ESSENTIAL COMPONENTS INCLUDED	
P&ID PRIMARY CONTAINMENT & SUPPRESSION POOL PURGE (VQ)	
W.A. H. ZIMMER NUCLEAR POWER STATION UNIT THE CINCINNATI GAS & ELECTRIC COMPANY COLUMBUS & SOUTHERN OHIO ELECTRIC COMPANY THE DAYTON POWER AND LIGHT COMPANY	
SCALE: NONE	DRAWING NO. M-103
DRAWN: J. LUBCZKI 11-6-72	ENGINEER: J. LUBCZKI 11-6-72
CHECKED: W. H. MULLER 4-17-74	ENGINEER: W. H. MULLER 4-17-74
APPROVED: J. LUBCZKI 4-2-75	ENGINEER: J. LUBCZKI 4-2-75

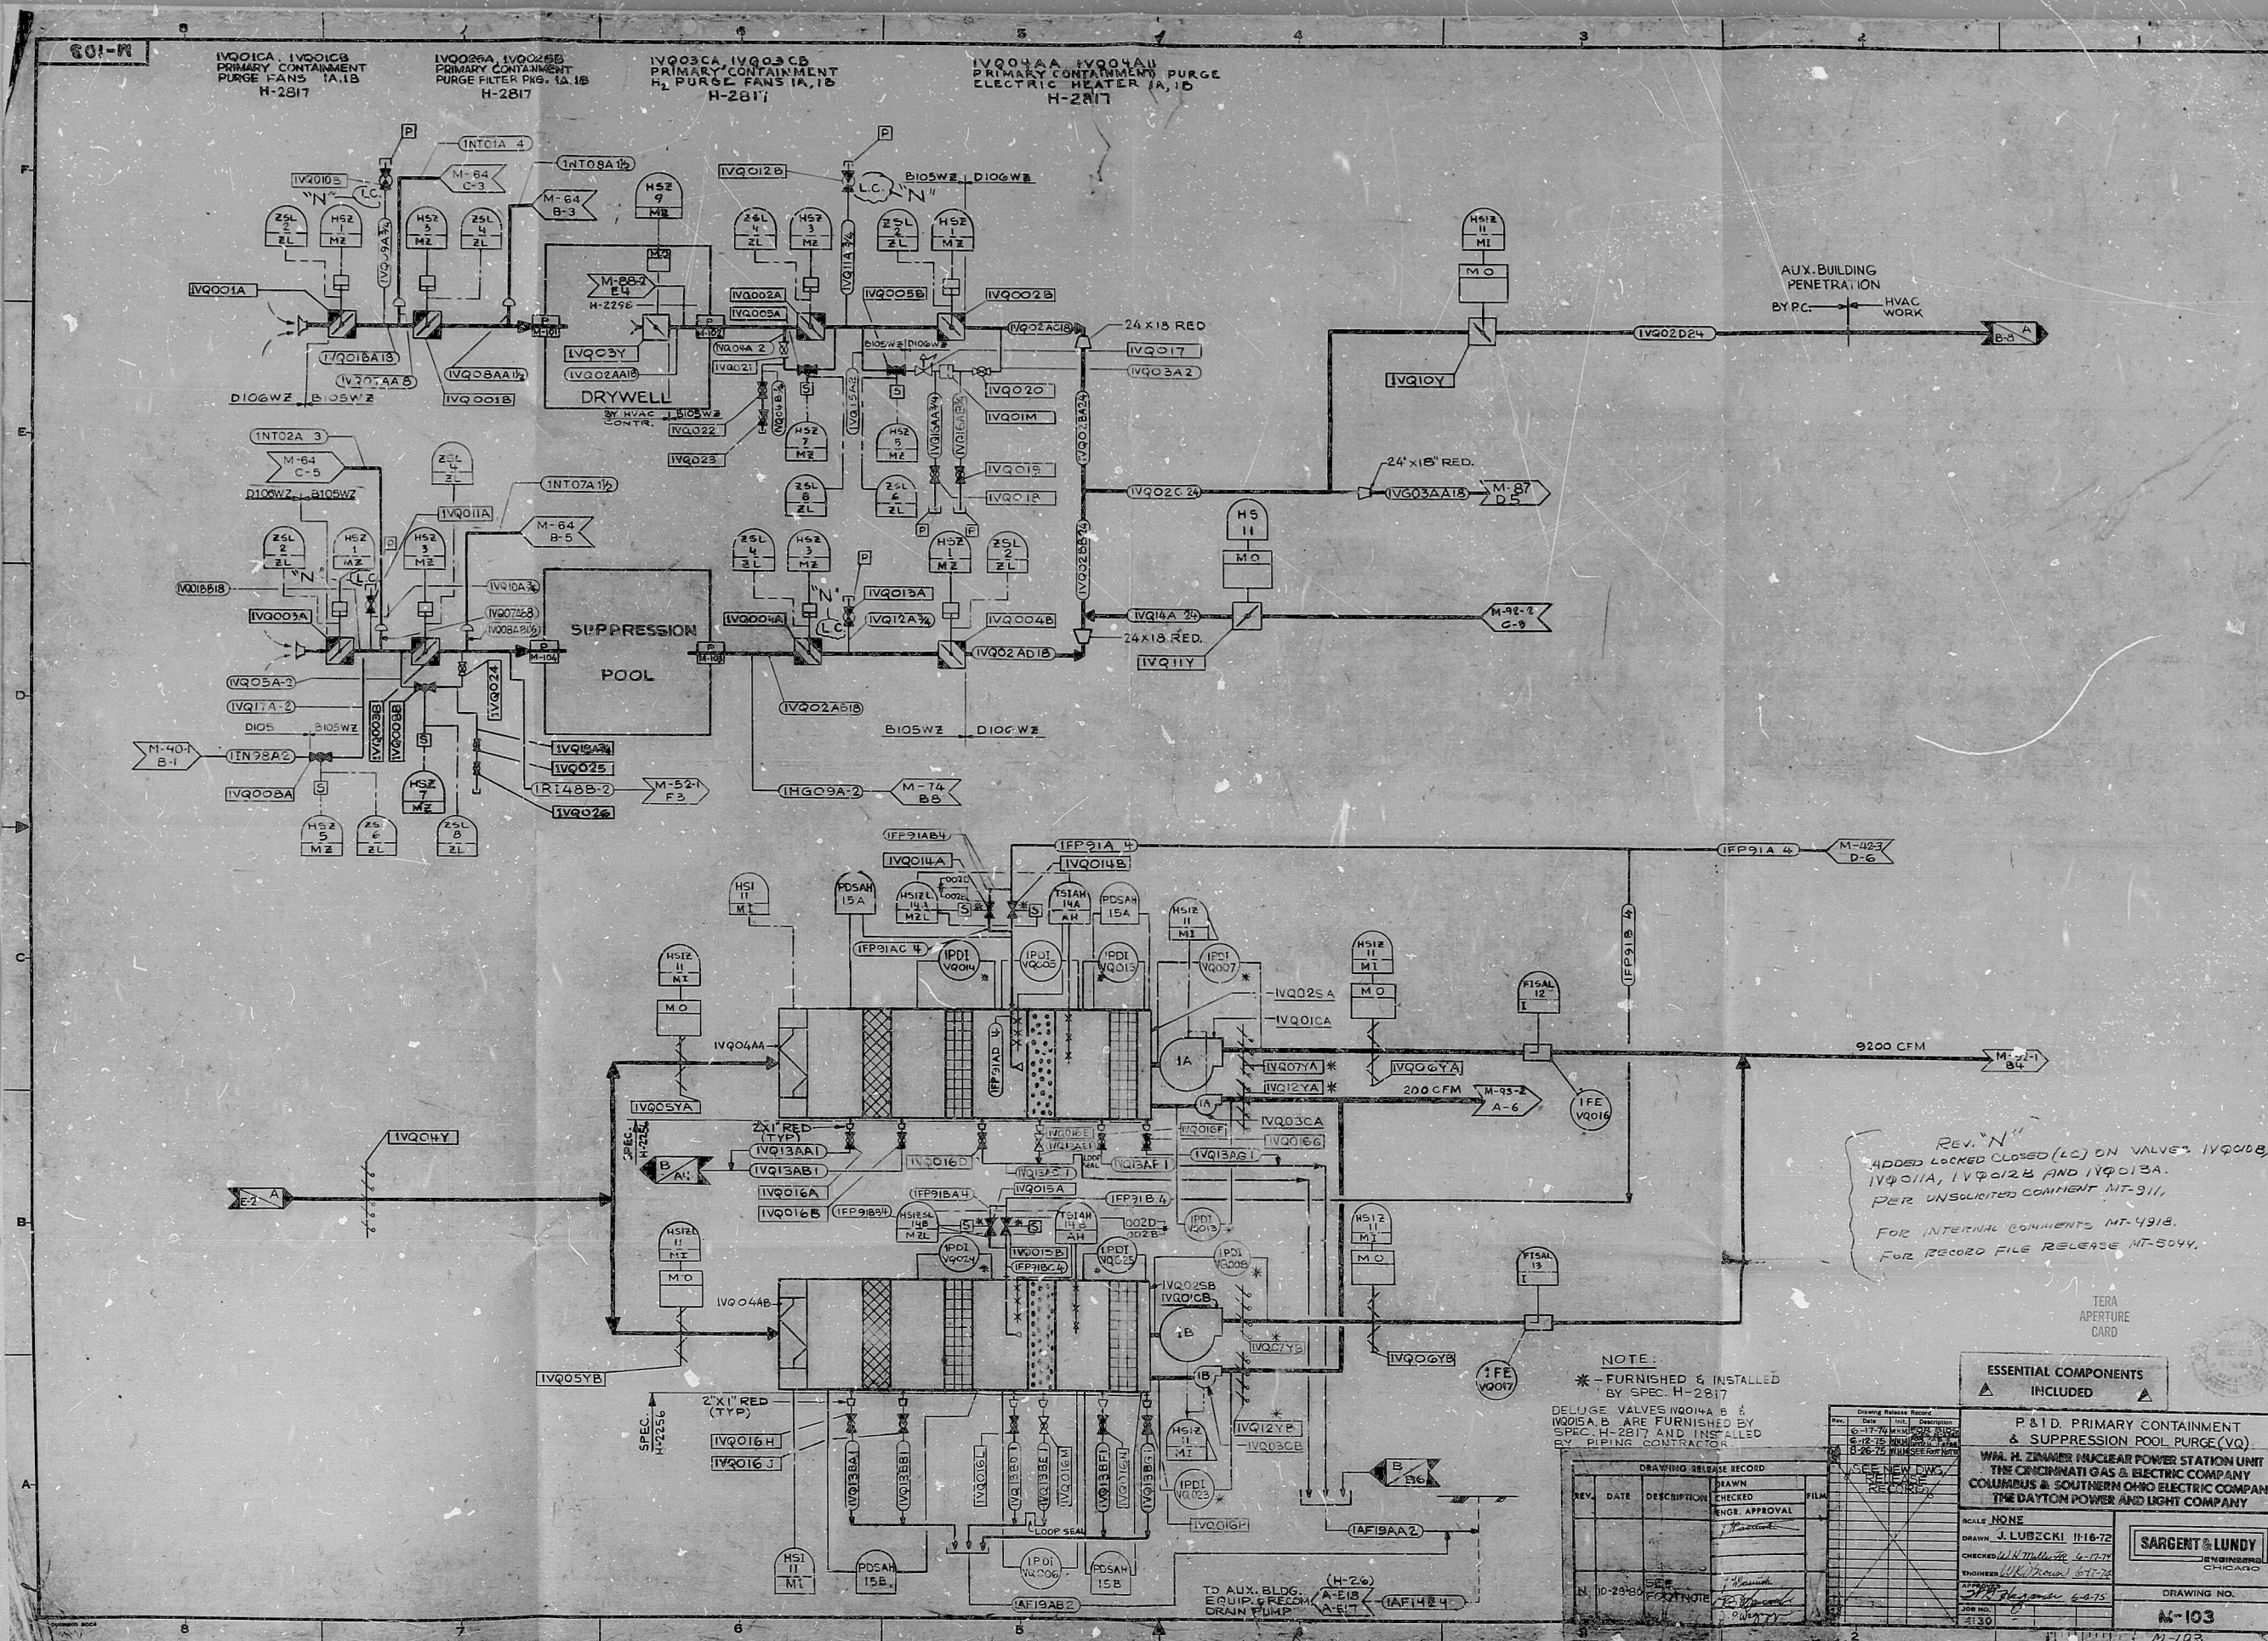
REV. "N"
ADDED LOCKED CLOSED (LC) ON VALVES IVQ008,
IVQ011A, IVQ012B AND IVQ013A.
PER UNSOLICITED COMMENT NT-311,
FOR INTERNAL COMMENTS NT-4918,
FOR RECORD FILE RELEASE NT-5044.
